**SUSQUEHANNA STEAM ELECTRIC STATION
PROPOSED AMENDMENT NO. 281 TO LICENSE NPF-14
AND PROPOSED AMENDMENT NO. 251 TO LICENSE NPF-22:
“APPLICATION FOR LICENSE AMENDMENT AND
RELATED TECHNICAL SPECIFICATION CHANGES
TO IMPLEMENT FULL-SCOPE ALTERNATIVE SOURCE
TERM IN ACCORDANCE WITH 10 CFR 50.67 – FOLLOWUP
TO REQUEST FOR ADDITIONAL INFORMATION (RAI)” Docket Nos. 50-387
PLA-6119 and 50-388**

Attachment – Markup of Drawing E105023 Sht.1

Markup of Drawing E105023 Sheet 1

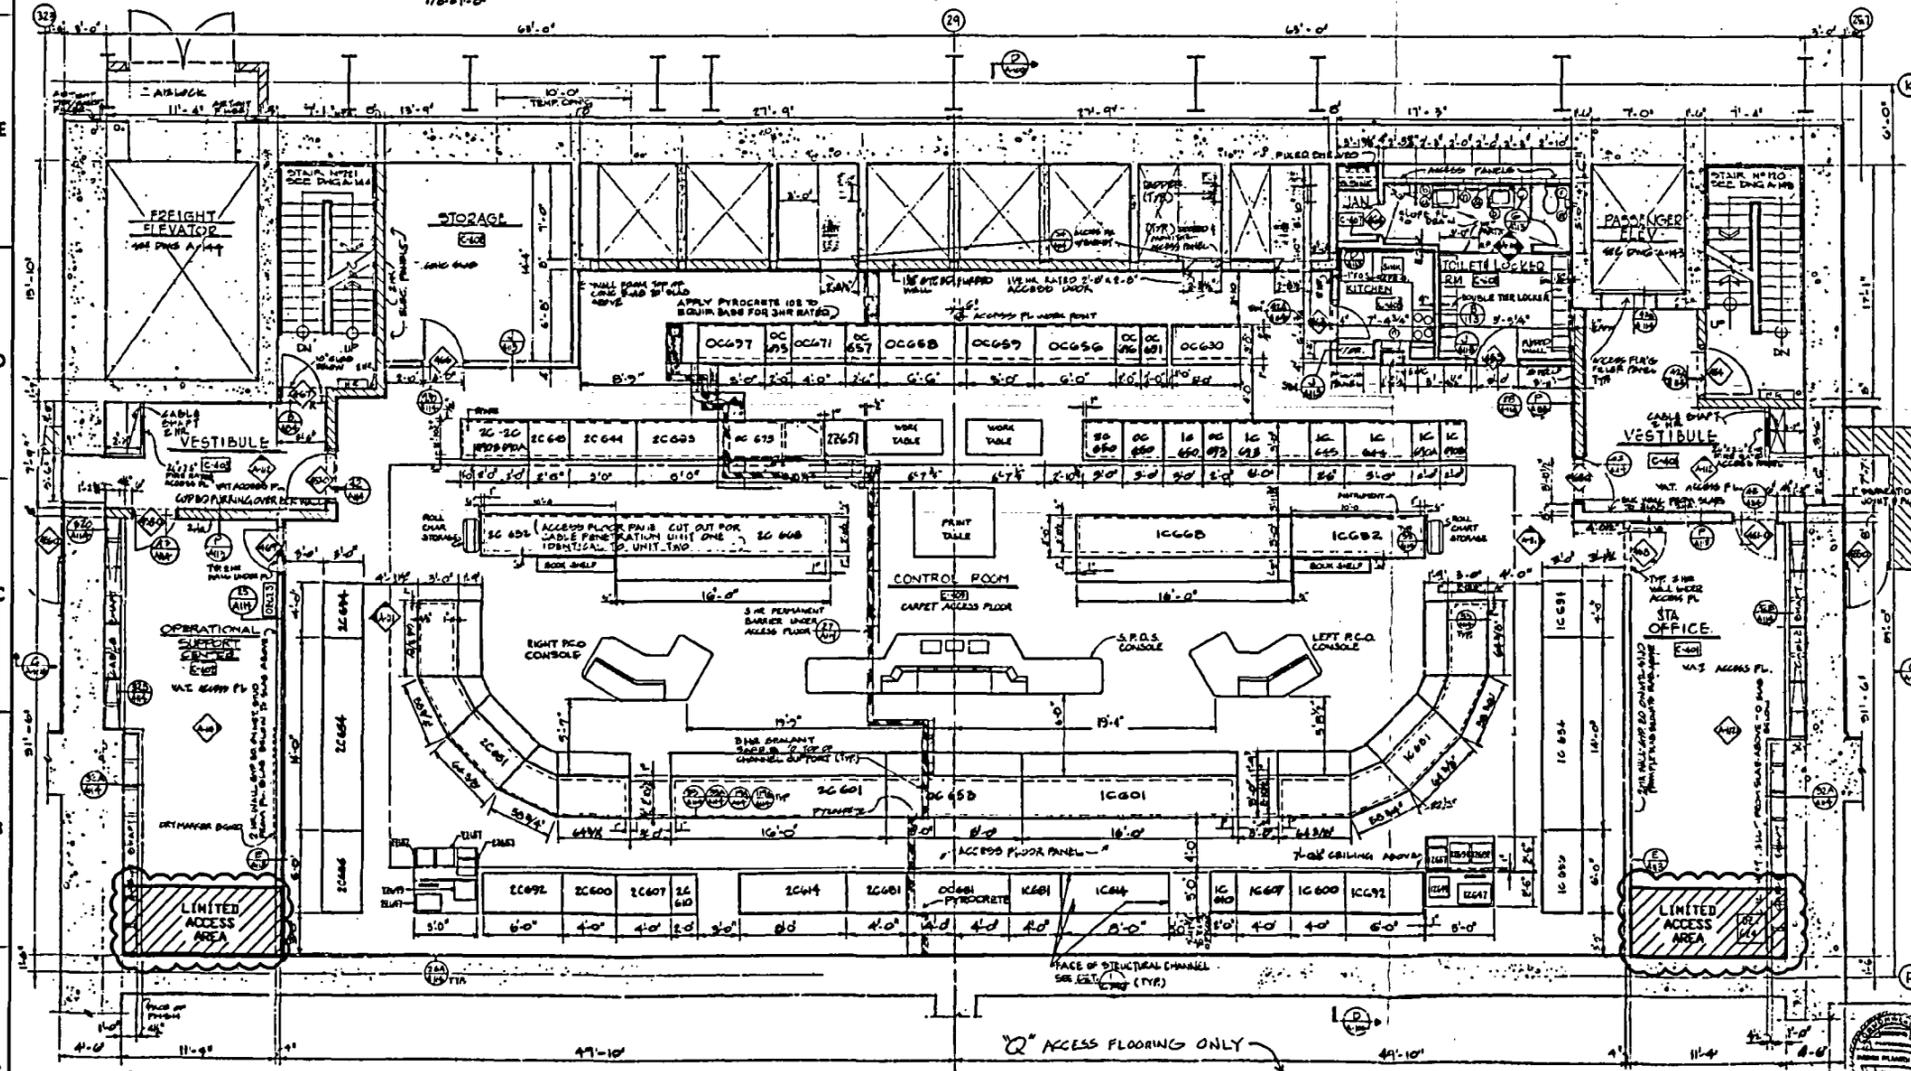
The purpose of this letter is to transmit the attached figure, inadvertently omitted from Reference 1, which provided PPL’s response to the NRC RAI Question #7. This marked up floor plan drawing shows the two office spaces on elevation 729’ that are adjacent to the main control room and two areas on elevation 741’ that are adjacent to the Technical Support Center (TSC), identified as an area of concern in the RAI.
